**Field Replacement of new MADI Back Card and mating with existing MADI Front Card**

# **RTS™** TECHNICAL BULLETIN

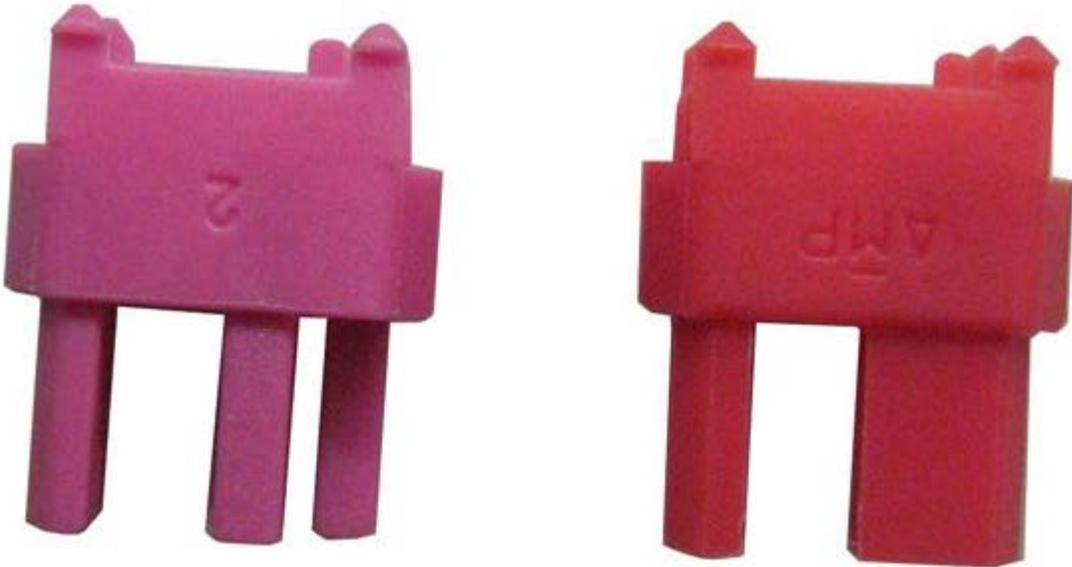
The new MADi Back Card arrives with a new connector key already installed. The new connector key is a different color. The new color is **violet**. The color of the old key is red.

The left key is the new Heather Violet key. The right key is the old Strawberry Red key.

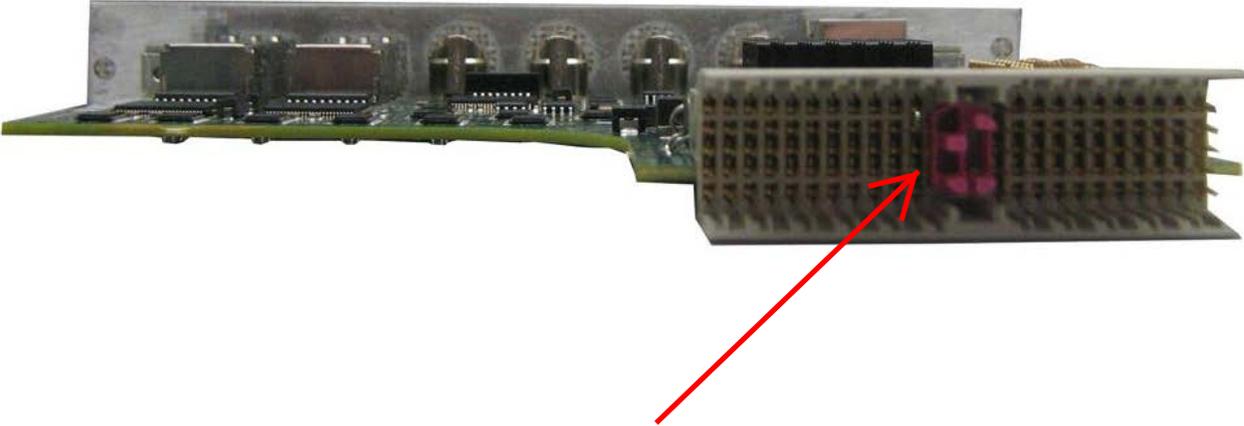
Shown below is a MADi Back Card with the new connector key.

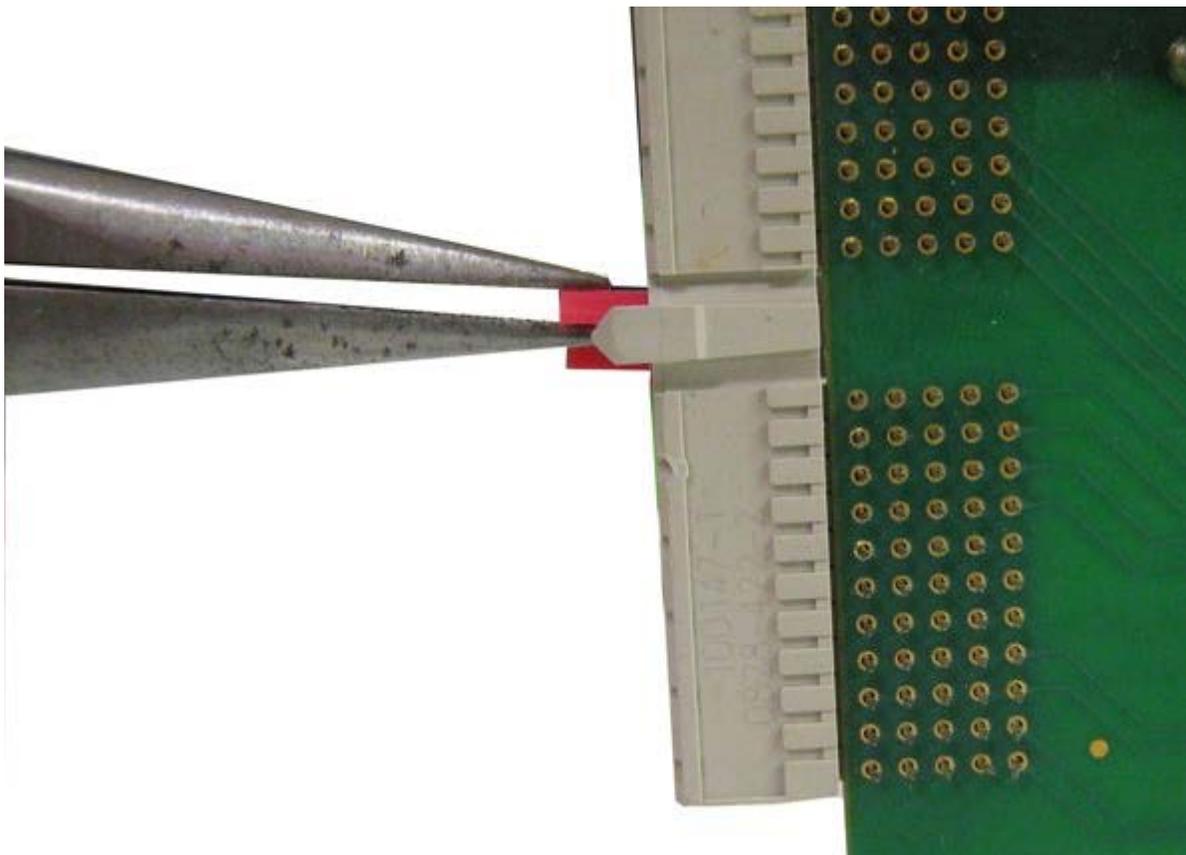
The old connector key is shown installed in the MADI Front Card.

3. Using the needle nose pliers, remove the old RED connector key.

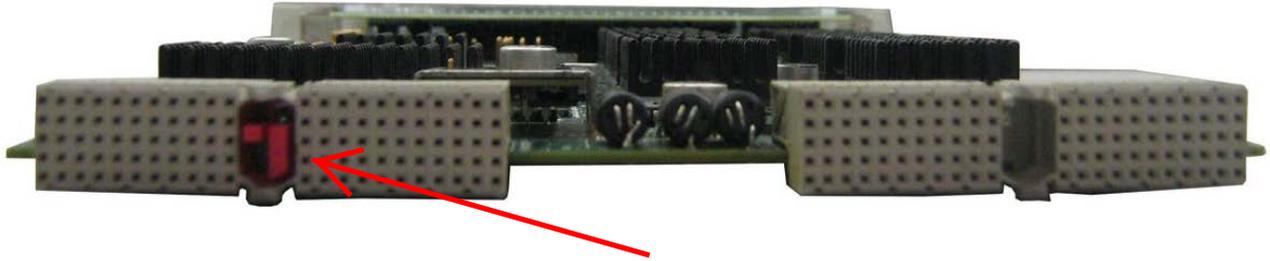
4. Insert the new VIOLET connector key into the MADI Front Card connector. Be sure to follow the proper key orientation. The key is not reversible. The mounting pins on all of the keys are polarized so the key cannot be installed in the wrong location or in the wrong orientation.
